Report: PUNCH LIST
Function: Test, Adjust, & Balance
Date: 02/04/2026
Completed By: National TAB

PROJECT
02-02-26 CULVERS - CHARLOTTE, NC

Project: 02-02-26 CULVERS - CHARLOTTE, NC

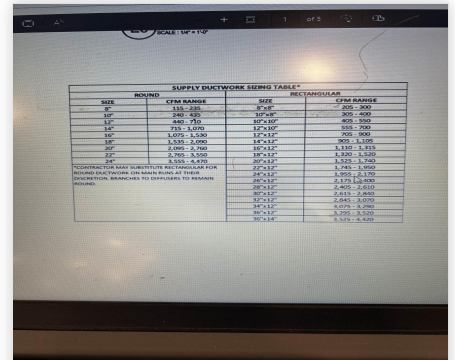
Issue Name : RTU-2 ductwork undersized
Description : RTU 2 is currently at 88% of design total flow. The ductwork from the unit was installed horizontally, this restricts the unit. On the MSET rooftop drawings refers to a note (M101) about proper ductwork size. Currently the supply ductwork 25x14 and also insulated inside. Supply pressure is at 1.50", the unit was at max amps 26.9a @61.5hz.

- **02/04/2026 National TAB - Jearod Ferrette**
 - I slowed the unit down by 2hz, to bring down the amps. Per the mechanical there is an email chain from Captive Air. The engineers wanted the unit to be ducted horizontally. This unit will be proportionally balance.
